Entergy Operations, Inc.
River Bend Station
5485 U.S. Highway 61N
St. Francisville, LA 70775

SUBJECT: License Amendment Request 2009-01
Application for Technical Specifications (TS) Change to Adopt NRC Approved
Generic Changes TSTF-163, TSTF-222, TSTF-230, and TSTF-306 to the
Improved Technical Specifications
River Bend Station, Unit 1
Docket No. 50-458
License No. NPF-47

RBF1-09-0009
RBG-46763

Description of Proposed Technical Specification Changes

3.6.2.3 Residual Heat Removal (RHR) Suppression Pool Cooling

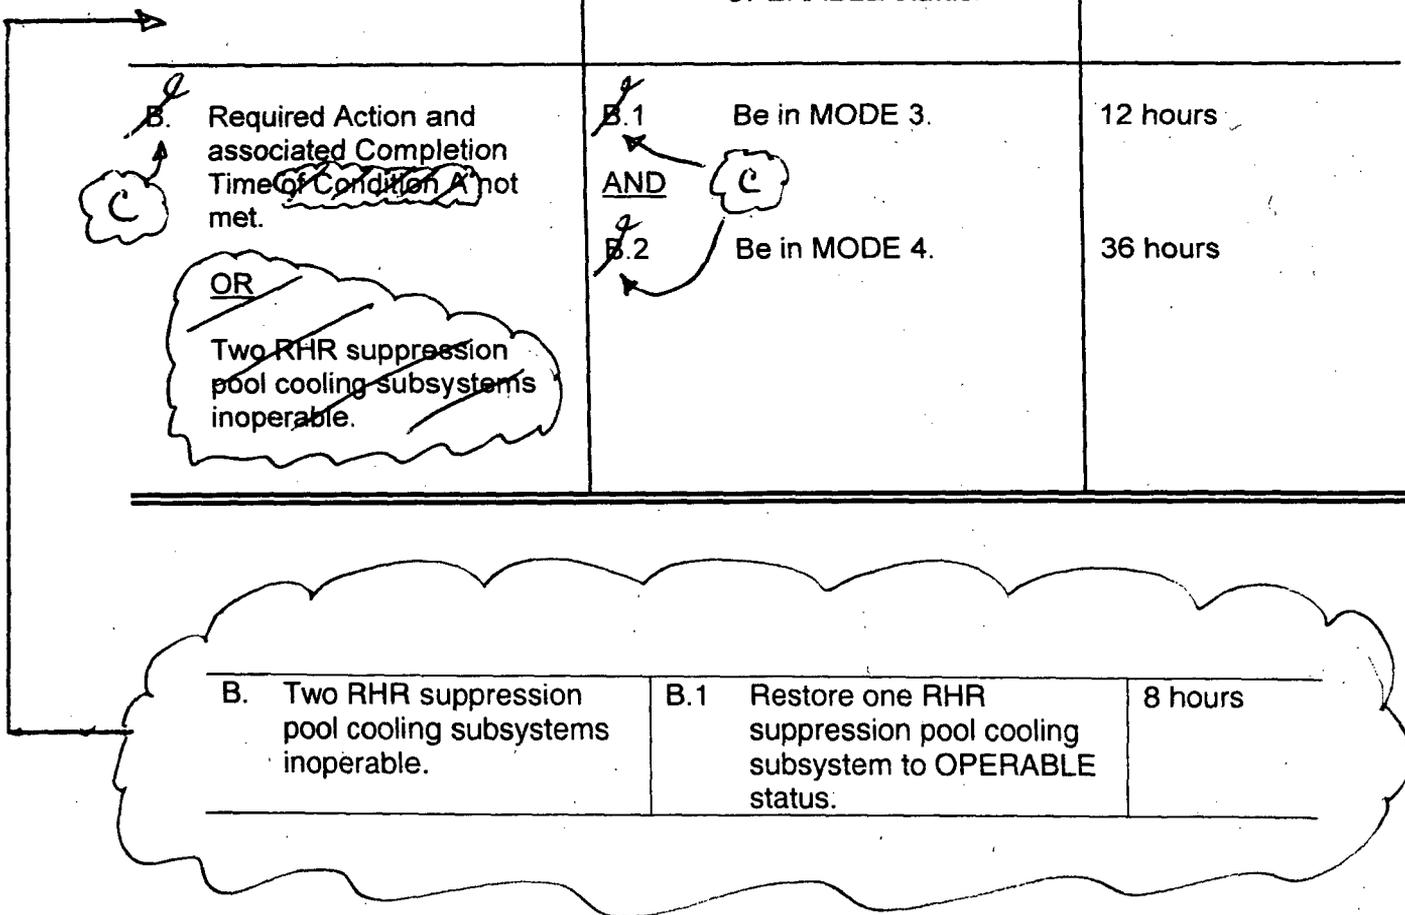
Limiting Condition for Operation (LCO) 3.6.2.3, "Residual Heat Removal (RHR) Suppression Pool Cooling," is revised to add a new ACTION (ACTION B) to allow two RHR suppression pool cooling subsystems to be inoperable for 8 hours. Due to this change, the second part of existing CONDITION B is deleted and the entire ACTION B is renumbered as ACTION C. This change is considered to be less restrictive than current requirements.

The current Technical Specifications require a unit shutdown in the event both RHR suppression pool cooling subsystems become inoperable. The proposed change would allow 8 hours to restore one RHR suppression pool cooling subsystem to OPERABLE status before initiating a unit shutdown. The proposed 8 hour time is considered appropriate since an immediate plant shutdown has the potential for resulting in a unit scram and discharge of steam to the suppression pool when both suppression pool cooling subsystems are inoperable and incapable of removing the generated heat. The 8 hours provides time to restore one of the subsystems prior to requiring a unit shutdown, yet is short enough that the probability of an accident occurring during this additional time is not significantly increased. The proposed change also serves to provide consistency between the requirements for RHR suppression pool cooling and LCO 3.6.1.7, "Primary Containment Unit Coolers," which currently allows both primary containment unit coolers to be inoperable for 8 hours.

If the Required Action and required Completion Time of Condition A cannot be met or if two RHR suppression pool cooling subsystems are inoperable, the plant must be brought to a MODE in which the LCO does not apply. To achieve this status, the plant must be brought to at least MODE 3 within 12 hours and to MODE 4 within 36 hours. The allowed Completion Times are reasonable, based on operating experience, to reach the required plant conditions from full power conditions in an orderly manner and without challenging plant systems.

With two RHR suppression pool cooling subsystems inoperable, one subsystem must be restored to OPERABLE status within 8 hours. In this condition, there is a substantial loss of the primary containment pressure and temperature mitigation function. The 8 hour Completion Time is based on this loss of function and is considered acceptable due to the low probability of a DBA and the potential avoidance of a plant shutdown transient that could result in the need of the RHR suppression pool cooling subsystems to operate.
